**TOWN OF PORTOLA VALLEY
ARCHITECTURAL AND SITE CONTROL COMMISSION (ASCC)
Monday, October 14, 2013
Special Field Meeting (time and place as listed herein)
7:30 PM – Regular ASCC Meeting
Historic Schoolhouse
765 Portola Road, Portola Valley, CA 94028**

MEMORANDUM

TO: ASCC
FROM: Tom Vlastic, Town Planner
DATE: October 10, 2013
RE: Agenda for October 14, 2013 ASCC Meeting

Proposed Site Plan

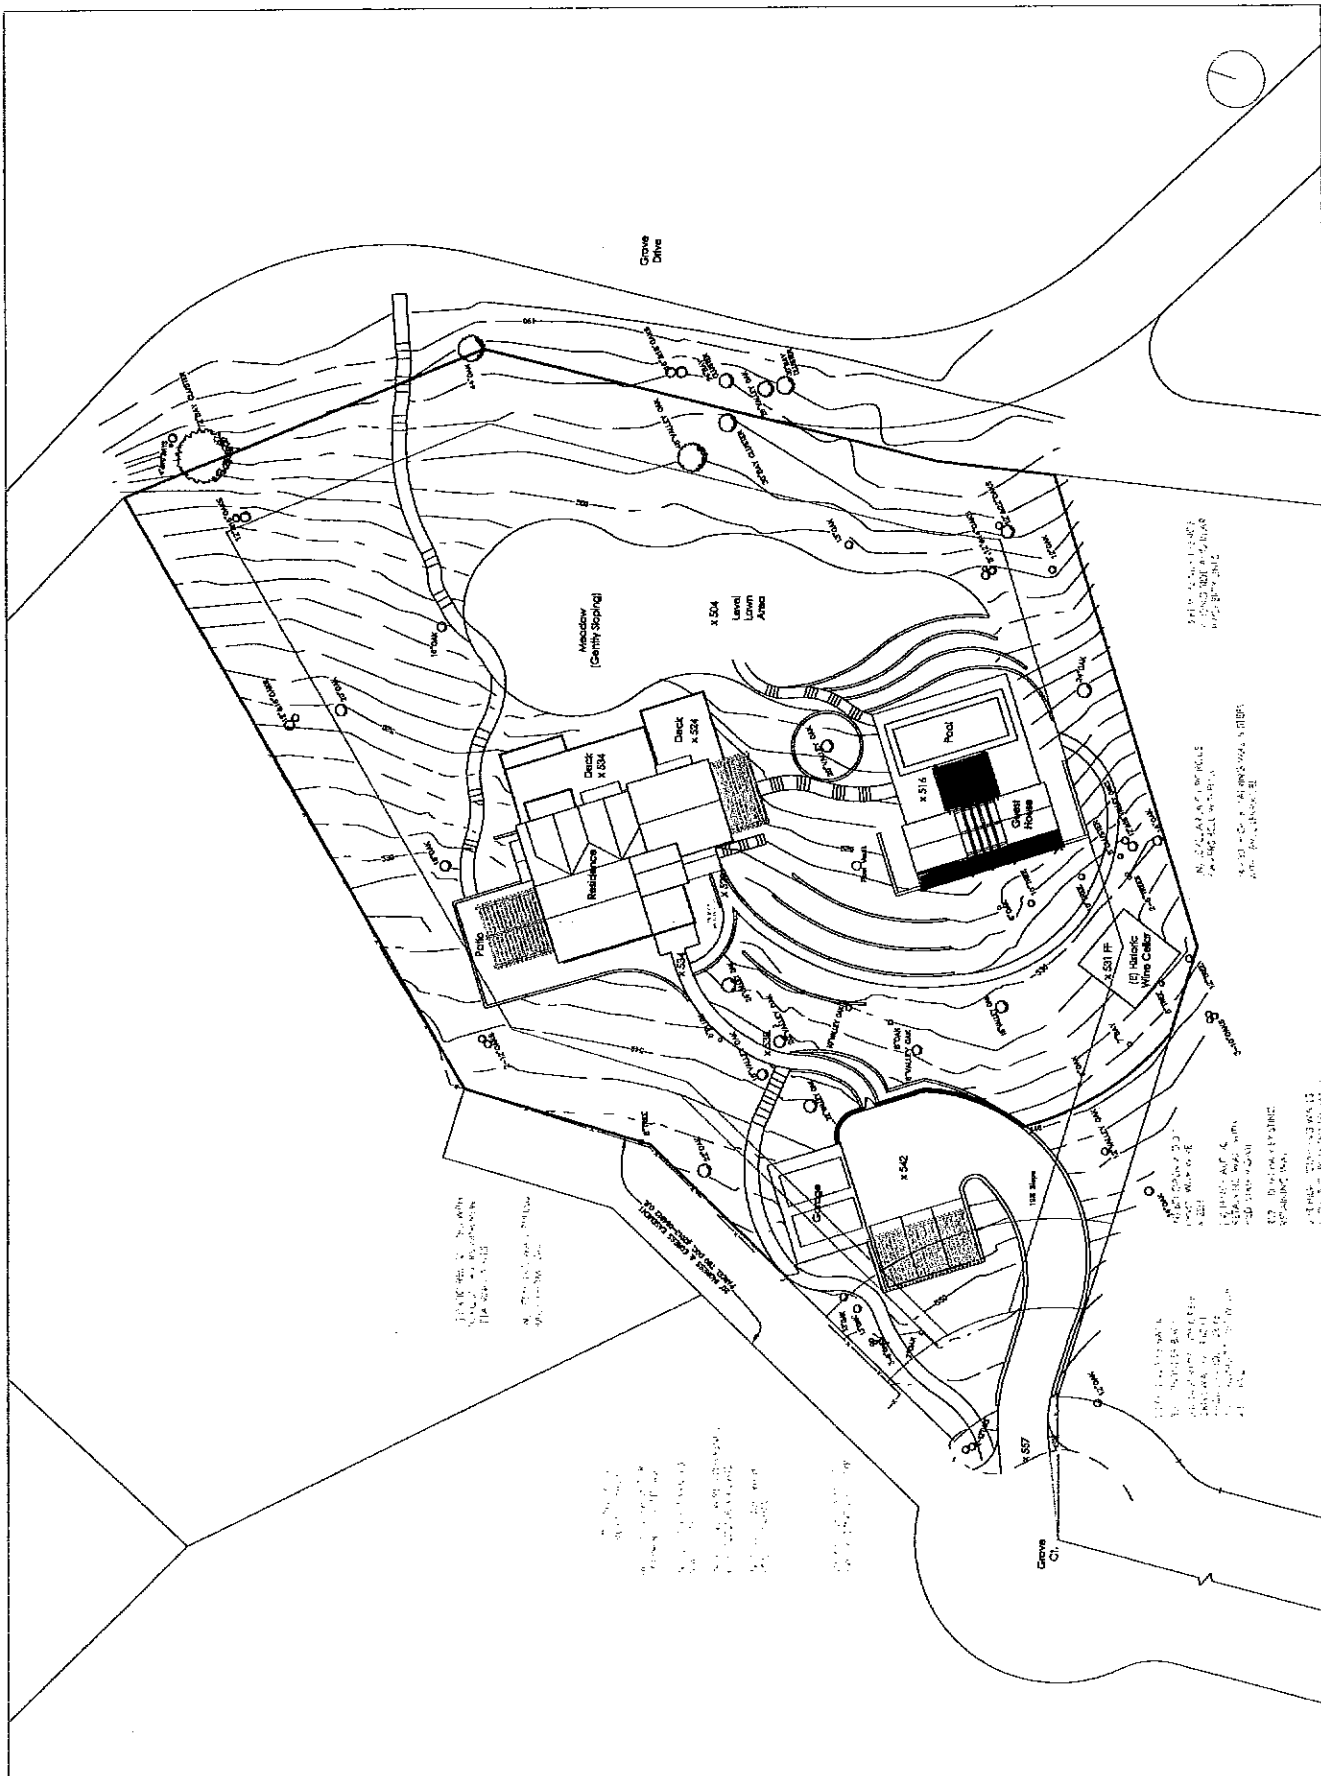
- a. Permit the proposed garage to encroach 15 feet into the required 20 foot northwest side yard. (Shown on Sheet A2.2.) This includes elimination of the existing driveway access from the easement, but does preserve space for a pathway that would connect to the existing stone pathway from the easement to the subject site and historic house. In any case, the majority of this existing, historic pathway material should be preserved or reused in the planned site work.

- b. Permit the guest parking area to have a 12-foot high trellis for screening that extends a maximum of 9 feet into the required 50-foot front yard setback. (Shown on Sheet A2.2.) Under averaging provisions a structure could extend 10 feet into the setback, but this structure does not meet the averaging provisions. Further, an ornamental garden structure, to a maximum of 12 feet can extend into a setback and a simple trellis without parking underneath could be considered a ornamental structure. These comparisons are offered mainly to show that the applicants, while dealing with site conditions and problems, have attempted to design to the spirit of the ordinance if not the specific standards. It is noted that the scope of parking is needed for zoning ordinance conformity to current residential standards.

**Proposed
Landscape Plan**

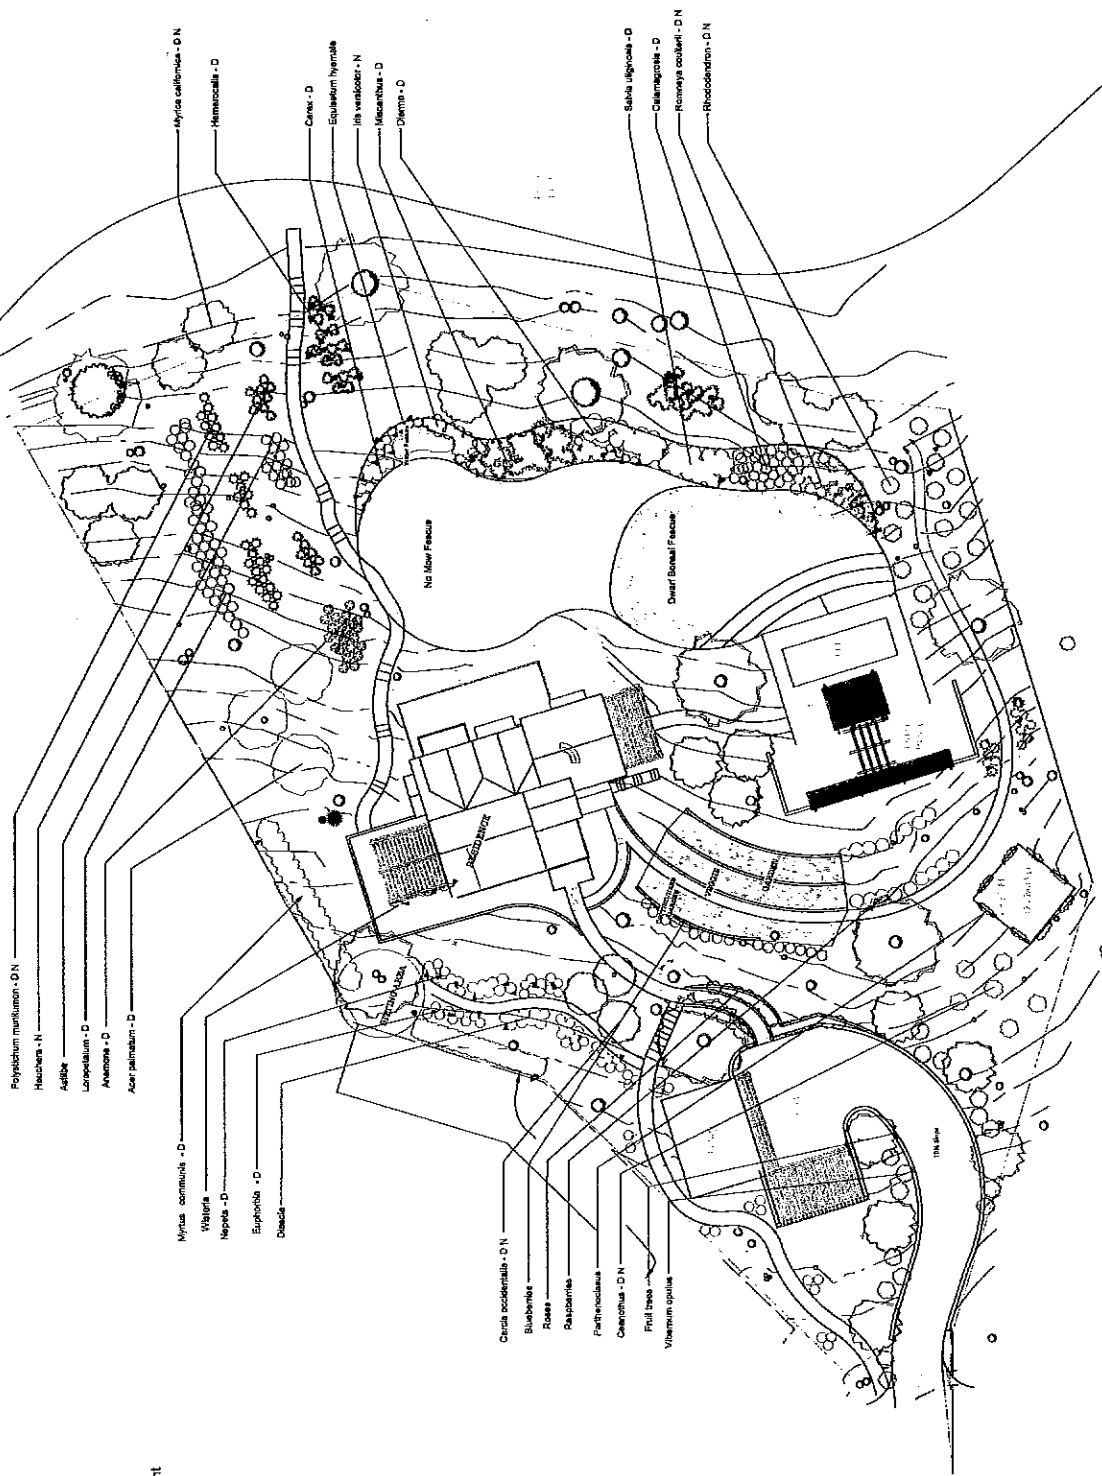
6. **Landscaping/fencing.** The plans do not identify any new fencing with the project. If any is planned it should be identified to the satisfaction of the ASCC. The concepts for landscaping are presented on Sheet A2.3. The approach and plant selection appear generally consistent with town guidelines. The site meeting, however, will provide the opportunity for the landscape concepts to be fully presented to the ASCC. Our two main preliminary comments are that there appears to be the need for some additional screen planting along the west and south sides of the garage/parking area and that every effort should be made to save and reuse the existing rock and stone pathways.

A2.5
 SHEET

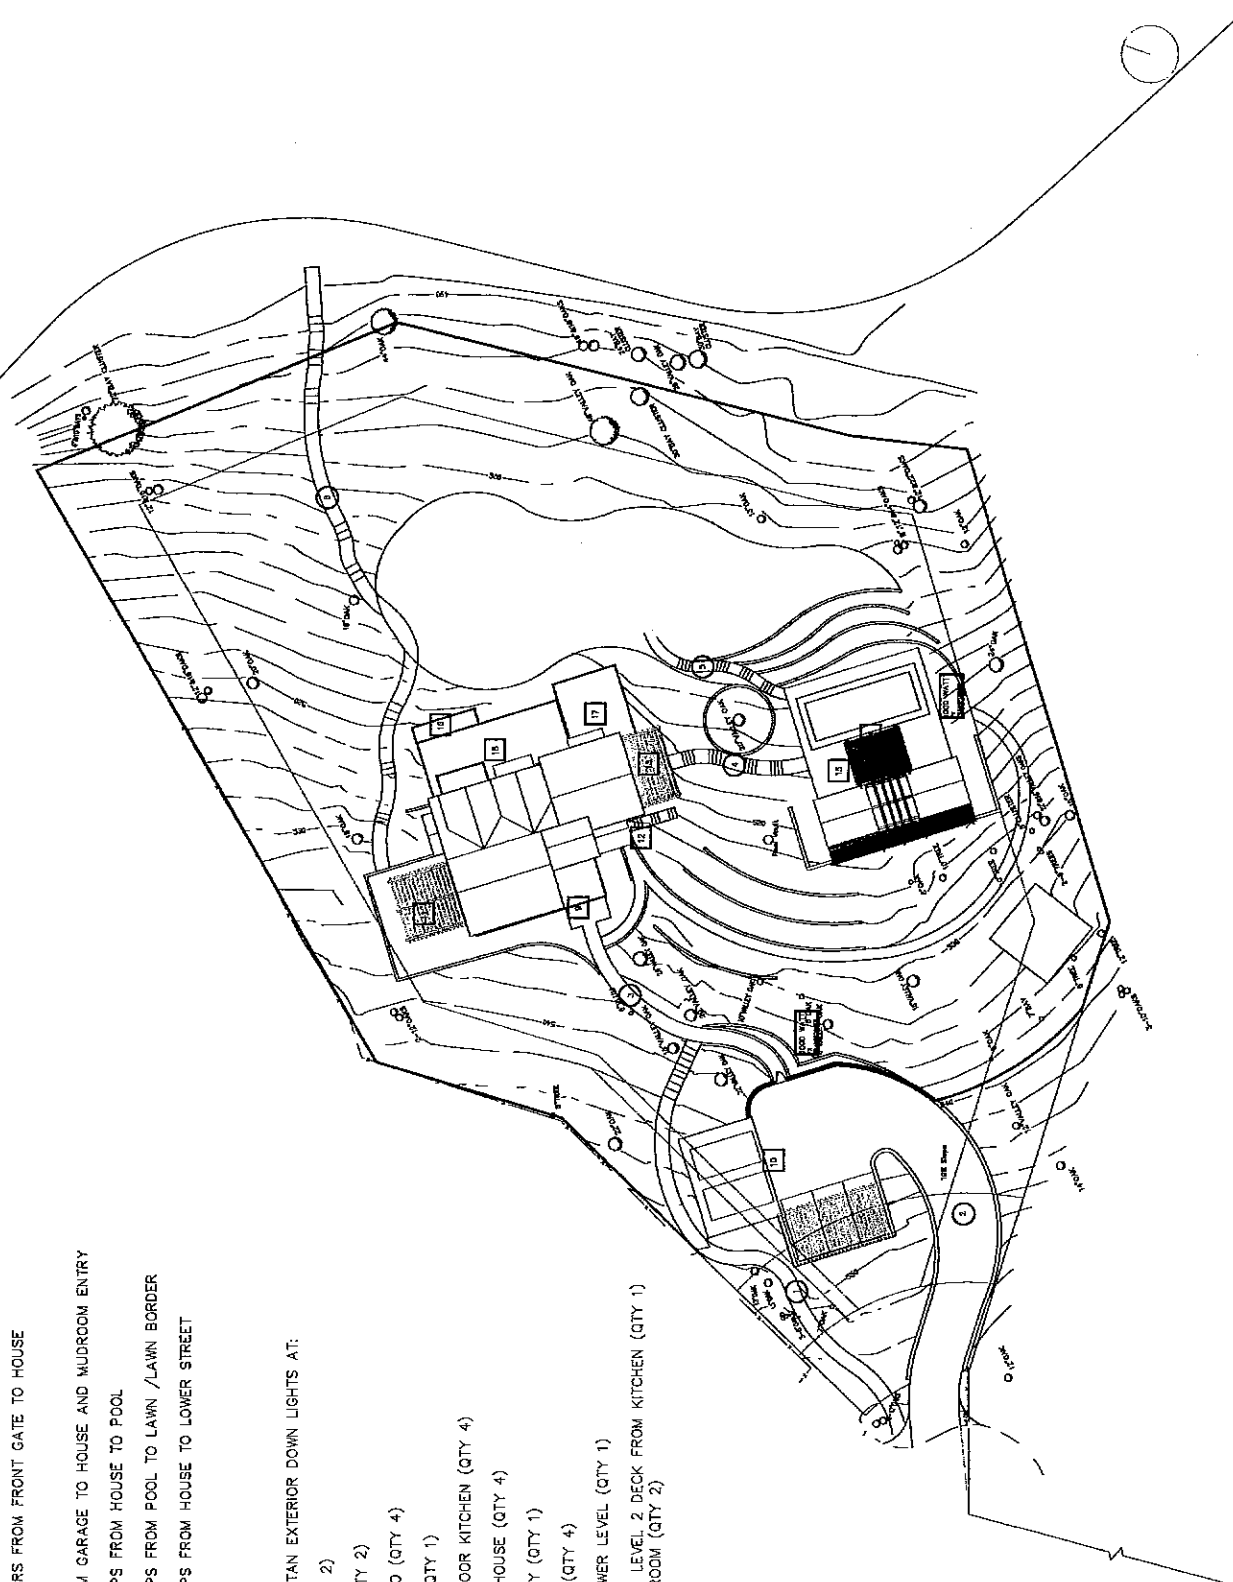
7. **Exterior Lighting.** The concepts for lighting are shown on plan Sheet A2.5 and fixture cut sheets are attached. The details for fixture placement need to eventually be defined to the satisfaction of the ASCC. The concepts should be discussed with the design team at the evening 10/14 ASCC meeting.

Tree Removal Plan

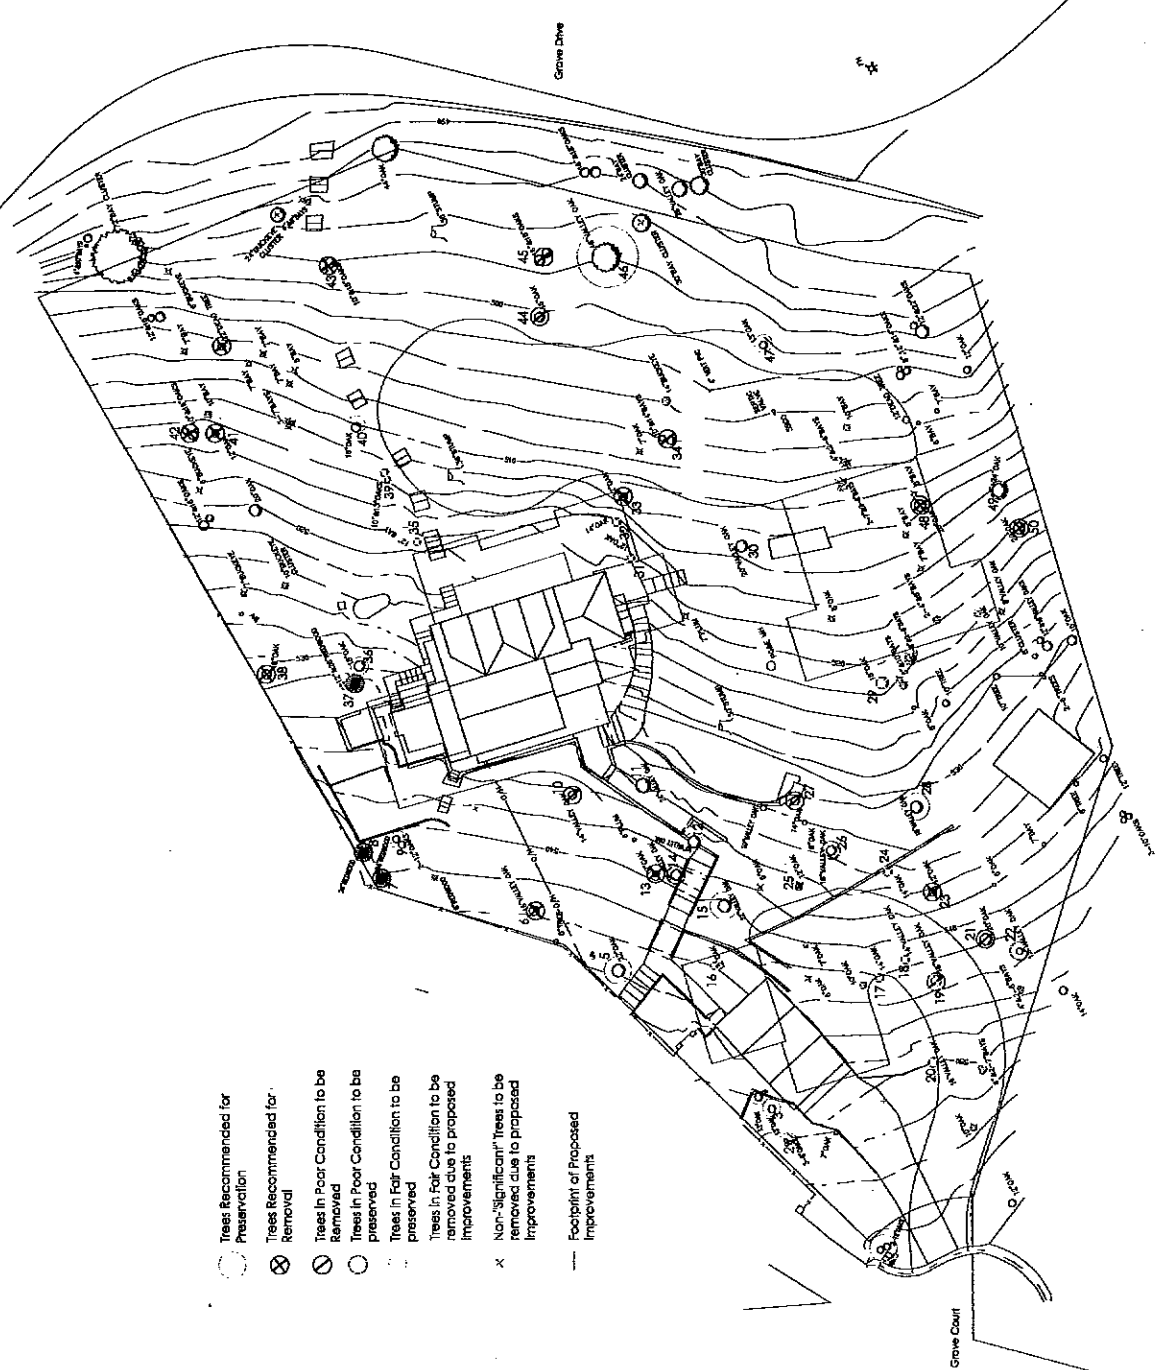
- Tree Survey Report, Arbor Resources, August 22, 2013. The trees considered in the report are identified by number on plan Sheet A2.6, and on this sheet tree removal by tree status and condition is noted.

**Proposed
Story Pole Plan**

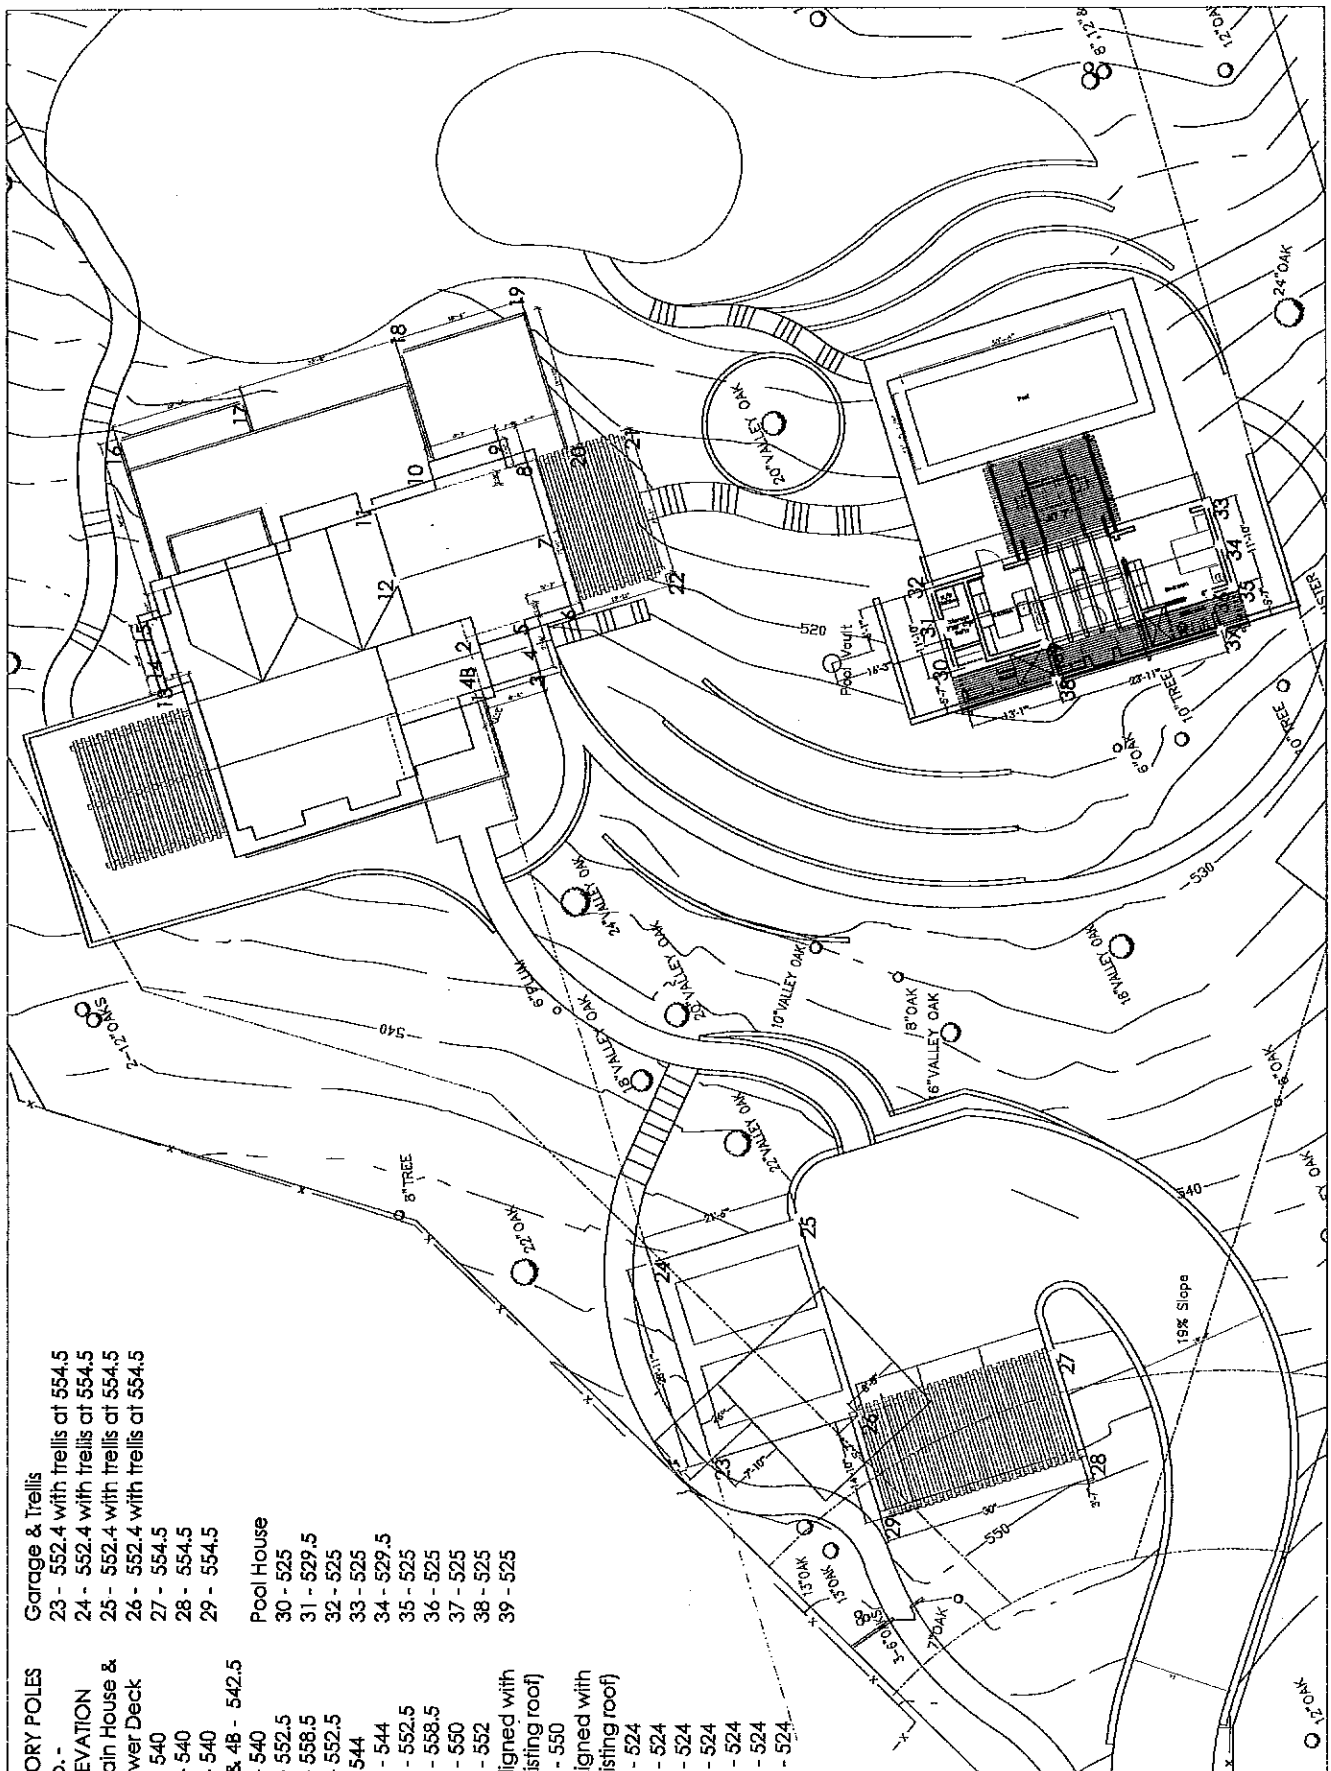
As noted at the head of this memorandum, the preliminary review process is to begin with a 4:00 p.m. site meeting on Monday October 14th 2013. To facilitate the site meeting, story poles have been set at the property to model the project as noted on enclosed plan Sheet A2.13.

**Existing
Exterior
Elevations**

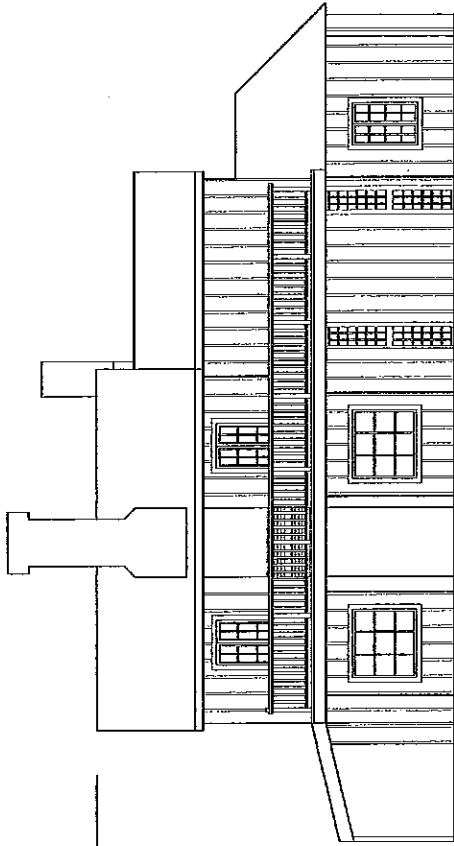
to be consistent with the historic character, but already achieve a height over adjacent grade of over 35 feet (Sheet A3.1). Thus, the proposed expansion with a roof form consistent with the historic architecture increases the height by roughly 2.5 feet over the existing condition. Without the variance the third floor expansion could not occur making use of the historic roof form.
